Southern Nuclear Operating Company
Vogtle Electric Generating Plant Units 3 and 4
Request for License Amendment and Exemption:
Addition of Steam Generator System (SGS) Thermal Relief Valves (LAR-17-012)

Vogtle Electric Generating Plant (VEGP) Units 3 and 4

Addition of Steam Generator System (SGS) Thermal Relief Valves

(LAR-17-012)

COL Appendix C (and plant-specific Tier 1) Figure 2.2.4-1 (Sheet 1) “Steam Generator System”

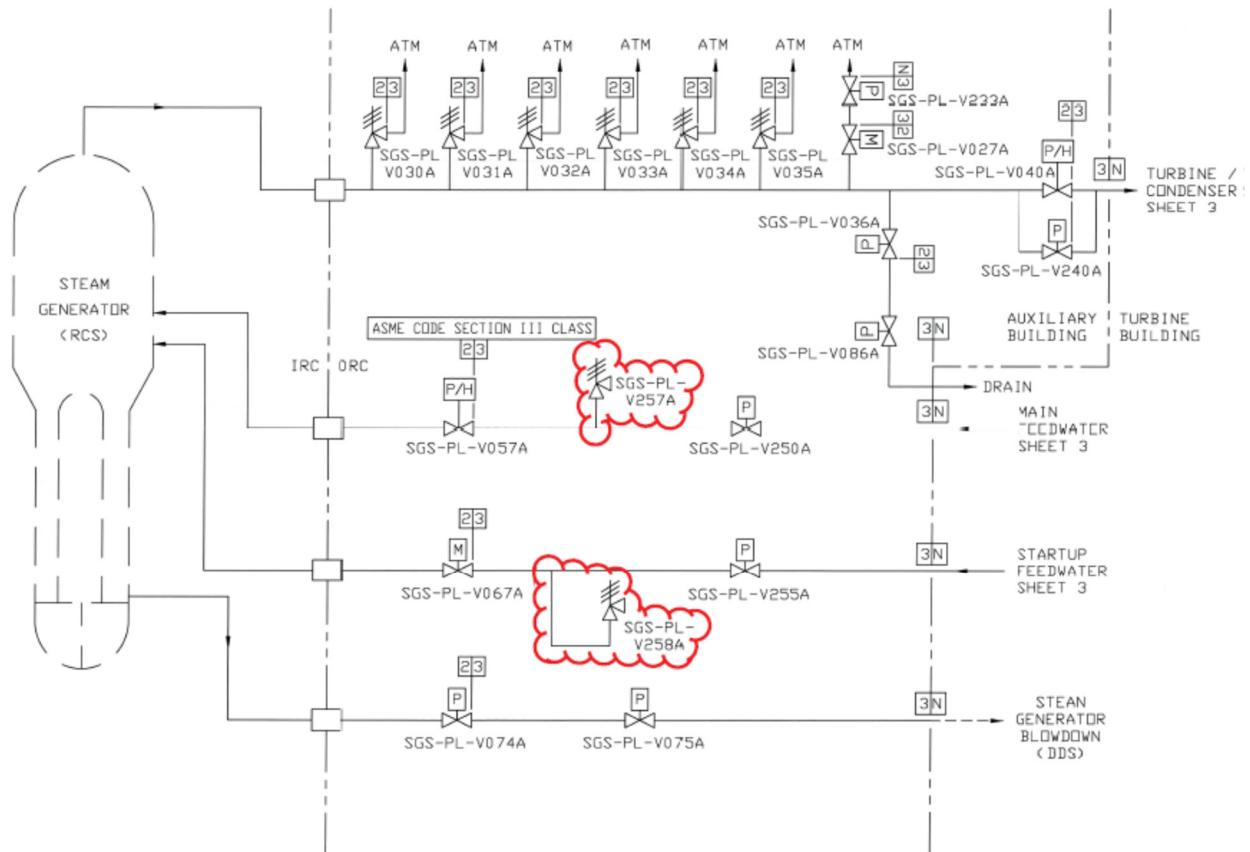
- COL Appendix C (and plant-specific Tier 1) Figure 2.2.4-1 (Sheets 1 and 2)
 - Figure 2.2.4-1 (Sheet 1) is revised to add main feedwater relief valve, SGS-PL-V257A, between valves SGS-PL-V057A and SGS-PL-V250A and to add startup feedwater relief valve, SGS-PL-V258A, between valves SGS-PL-V067A and SGS-PL-V255A.

- Tier 1 Figure 2.2.4-1 (Sheets 1 and 2):
 - Figure 2.2.4-1 (Sheet 1) is revised to add main feedwater relief valve, SGS-PL-V257A, between valves SGS-PL-V057A and SGS-PL-V250A and to add startup feedwater relief valve, SGS-PL-V258A, between valves SGS-PL-V067A and SGS-PL-V255A.

Revise COL Appendix C (and plant-specific Tier 1) Figure 2.2.4-1 (Sheet 1) as follows:

COL Appendix C (and plant-specific Tier 1) Figure 2.2.4-1 (Sheet 2) "Steam Generator System"

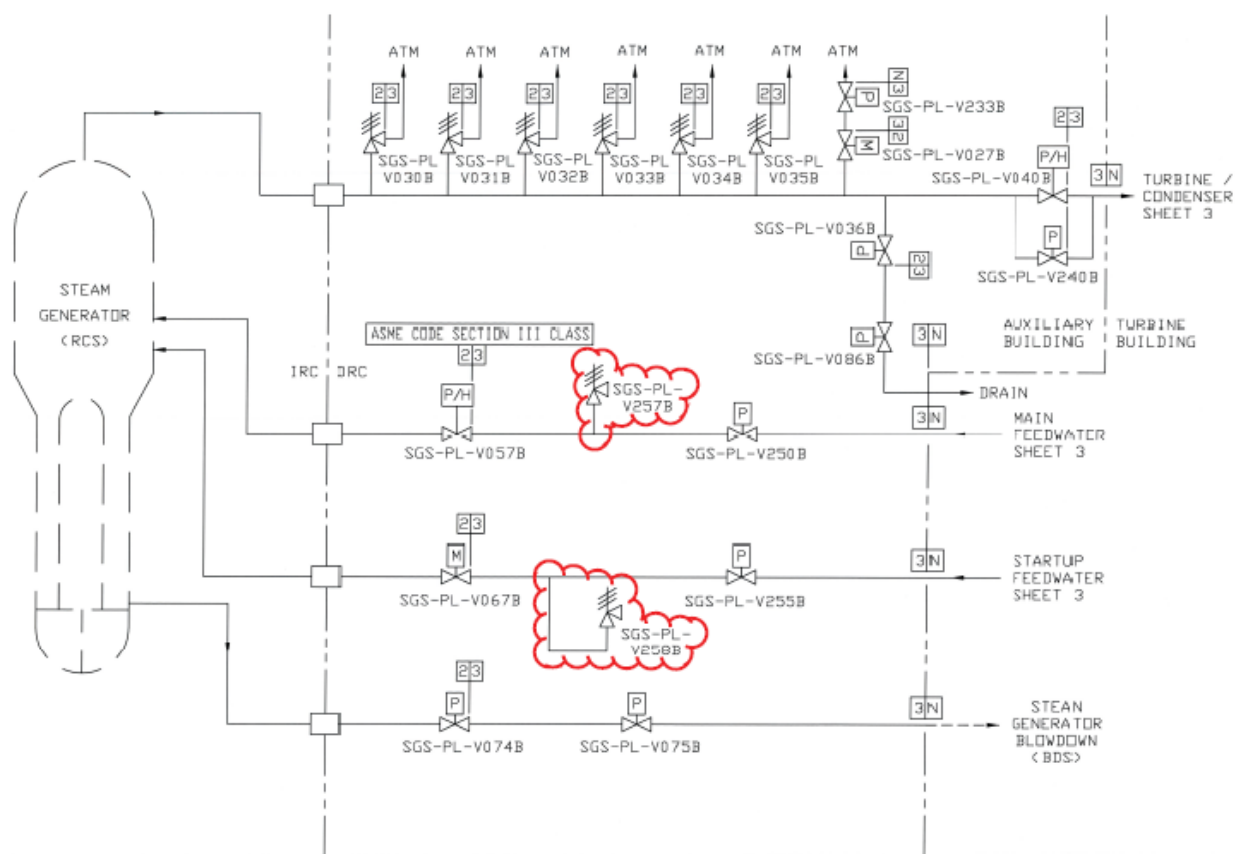
- Figure 2.2.4-1 (Sheet 2) is revised to add main feedwater relief valve, SGS-PL-V257B, between valves SGS-PL-V057B and SGS-PL-V250B and to add startup feedwater relief valve, SGS-PL-V258B, between valves SGS-PL-V067B and SGS-PL-V255B.

- Figure 2.2.4-1 (Sheet 2) is revised to add main feedwater relief valve, SGS-PL-V257B, between valves SGS-PL-V057B and SGS-PL-V250B and to add startup feedwater relief valve, SGS-PL-V258B, between valves SGS-PL-V067B and SGS-PL-V255B.

Revise COL Appendix C (and plant-specific Tier 1) Figure 2.2.4-1 (Sheet 2) as follows:

UFSAR Figure 10.3.2-1 (Sheet 1) “Simplified Main Steam Piping and Instrumentation Diagram (Safety-Related System) (REF) SGS 001”

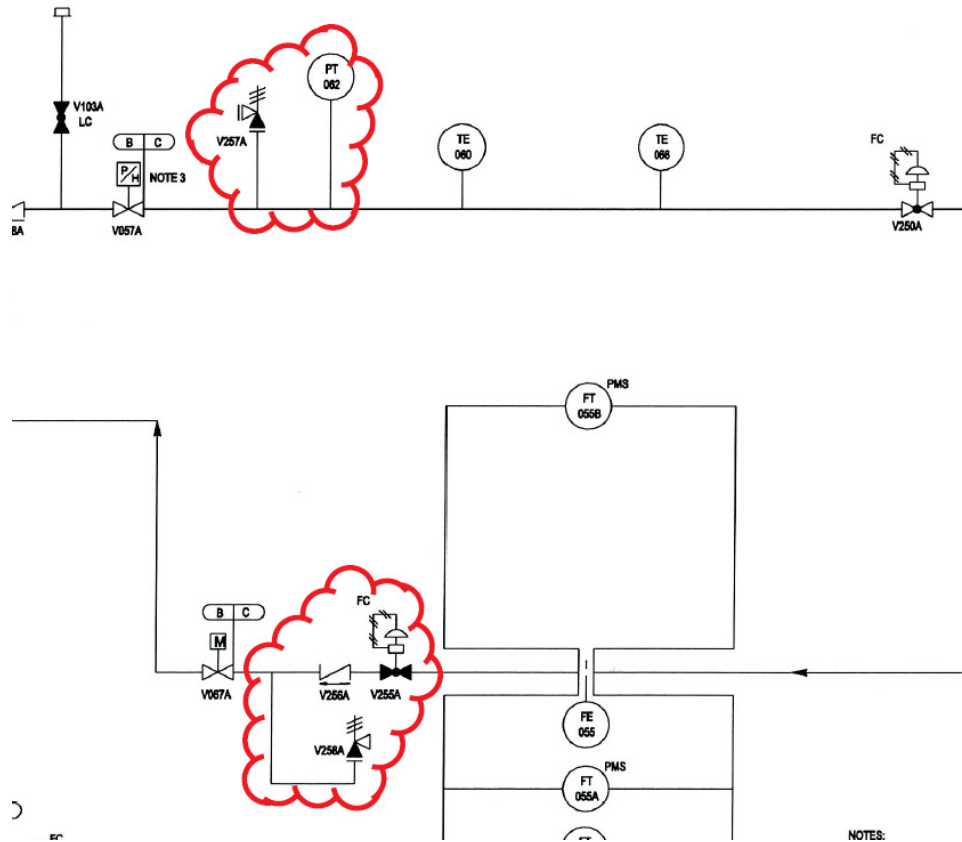
- UFSAR Figure 10.3.2-1 (Sheets 1 and 2)
 - Revise Sheet 1 to add main feedwater thermal relief valve, SGS-PL-V257A, between valves SGS-PL-V057A and SGS-PL-V250A, and to add startup feedwater thermal relief valve, SGS-PL-V258A, between valves SGS-PL-V067A and SGS-PL-V256A. The location of the startup feedwater check valve, SGS-PL-V256A, does not adversely affect the relieving capabilities of the new thermal relief valve as the check valve serves to prevent backflow.

- UFSAR Figure 10.3.2-1 (Sheets 1 and 2)
 - Revise Sheet 1 to add main feedwater thermal relief valve, SGS-PL-V257A, between the MFIV and MFCV, and add startup feedwater thermal relief valve, SGS-PL-V258A, between the SFIV and startup feedwater check valve.

Revise Figure 10.3.2-1 (Sheet 1), as shown in the excerpt below:

UFSAR Figure 10.3.2-1 (Sheet 2) "Simplified Main Steam Piping and Instrumentation Diagram (Safety-Related System) (REF) SGS 002"

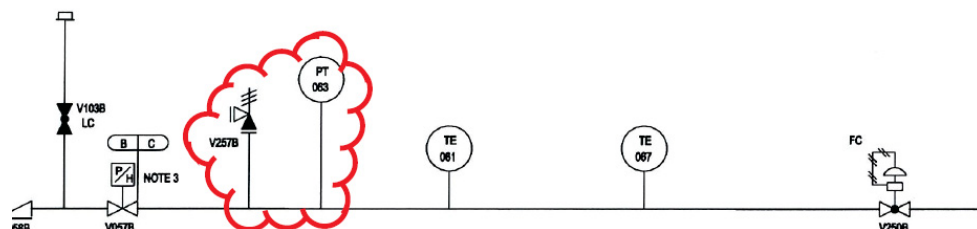
- Revise Sheet 2 to add main feedwater thermal relief valve, SGS-PL-V257B, between valves SGS-PL-V057B and SGS-PL-V250B, and add startup feedwater thermal relief valve, SGS-PL-V258B, between valves SGS-PL-V067B and SGS-PL-V256B. The location of the startup feedwater check valve, SGS-PL-V256B, does not adversely affect the relieving capabilities of the new thermal relief valve as the check valve serves to prevent backflow.

- Revise Sheet 2 to add main feedwater thermal relief valve, SGS-PL-V257B, between the MFIV and MFCV, and add startup feedwater thermal relief valve, SGS-PL-V258B, between the SFIV and startup feedwater check valve.

Revise Figure 10.3.2-1 (Sheet 2), as shown in the excerpt below:
